Re: FortisBC Energy Inc. - Application for A Certificate of Public Convenience and Necessity for the Okanagan Capacity Upgrade Project ~ Project No. 1599152

INTERVENER INFORMATION REQUEST NO. 1

**FortisBC Energy Inc. (“FEI”) Application for A Certificate of Public Convenience
and Necessity (“CPCN”) for the Okanagan Capacity Upgrade
Project No. 1599152**

Figure 3-7: ITS Peak Demand vs. Capacity

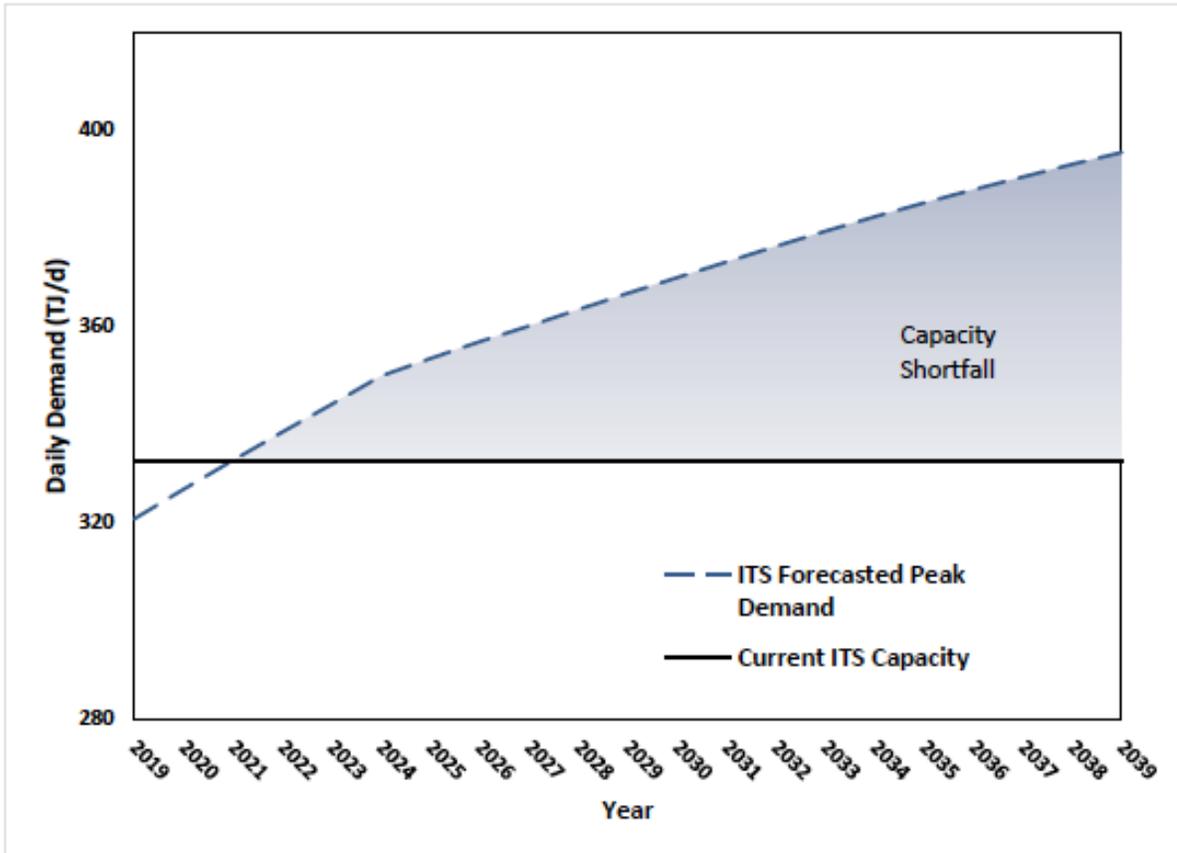
- 2.1 Please state when FEI first became aware of the expected capacity shortfall.
- 2.2 Why did FEI wait until November 2020 to make an application for the proposed upgrade when the capacity shortfall is expected to occur in 2021?
 - 2.2.1 Would FEI have been able to undertake different options if it had addressed the issue earlier? Please explain.
 - 2.2.1.1 If yes, what other options could FEI have introduced, and at approximately what cost?
- 2.3 To what extent could FEI utilize capacity-related DSM measures to defer the increase? Please identify the types of measures and the potential impacts that might have been employed.

Figure 3-10: Lavington and Lumby

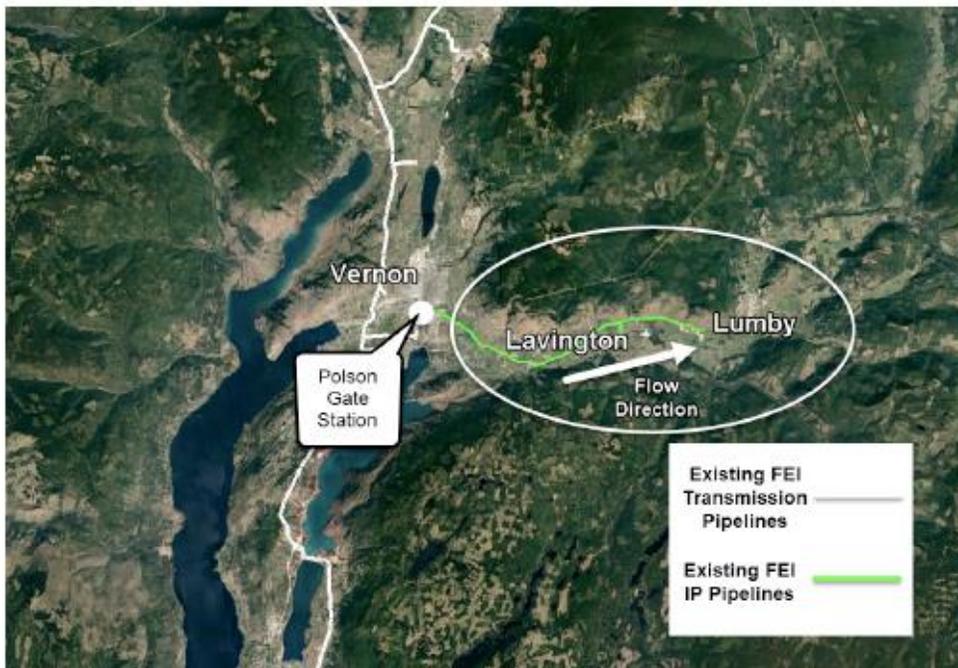
3.1 Could FEI undertake capacity-related DSM measures specifically targeted at those communities likely to experience a capacity shortfall? Please explain why or why not.

3.1.1 If yes, to what extent has FEI considered this option?

Figure 4-5: Overview Map of Alternative 4

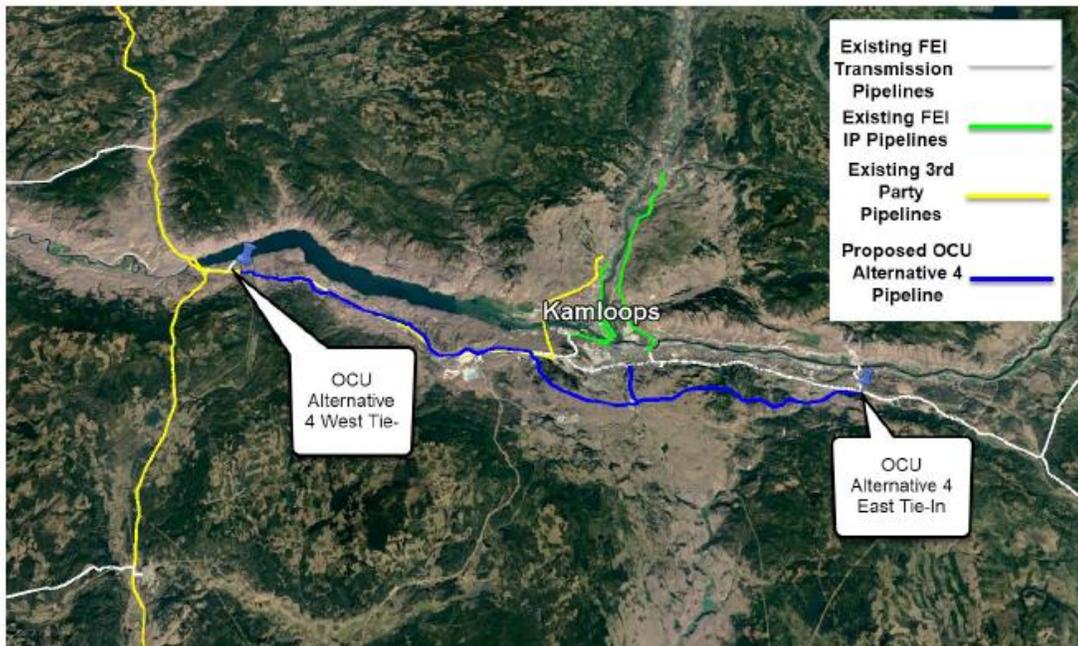
- 10.1 Is it fair to say that FEI screened out Alternative 4 primarily because it could not be built in the timeframes required for the winter of 2022/2023?
- 10.2 At what point would FEI have needed to conduct its initial analysis to have permitted Alternative 4 to be a viable option?
 - 10.2.1 Why was this not undertaken?
 - 10.2.1.1 Did the regulatory regime influence FEI's decision-making with respect to capital spending with respect to this project in any way whatsoever? Please explain.
- 10.3 Recognizing that FEI conducted a 'comprehensive evaluation' before screening out Alternatives 4 and 5, please provide a general statement of the benefits of Alternative 4.
- 10.4 Please provide a general statement of the detriments of Alternative 4.

Figure 5-4: Proposed Resources and Organizational Chart

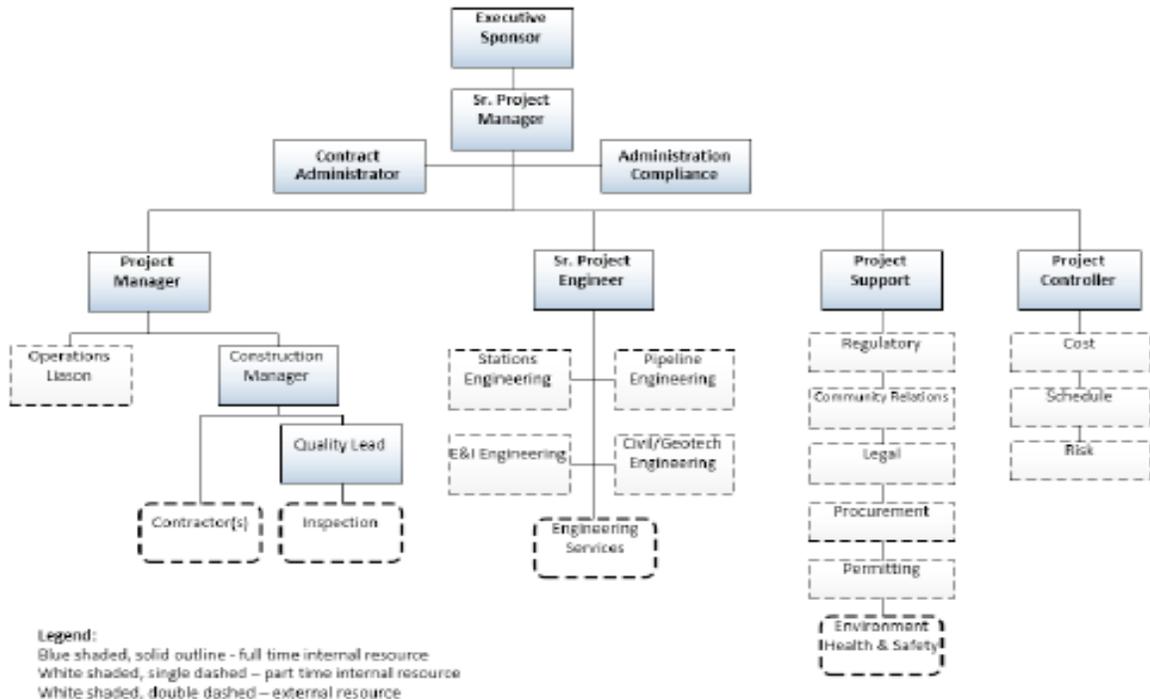
- 29.1 The CEC is unable to determine definitively which selections would be considered double-dashed and those single-dashed. Please confirm or otherwise clarify if the Contractor, Inspection, Engineering Services and Environment Health and Safety positions are the external resources.
- 29.2 Please explain why the Environment Health and Safety position is an external resource.
- 29.3 Does FEI allocate time for the part-time internal resources to the Project costing? Please explain.
- 30. Reference: Exhibit B-1-2, page 81**
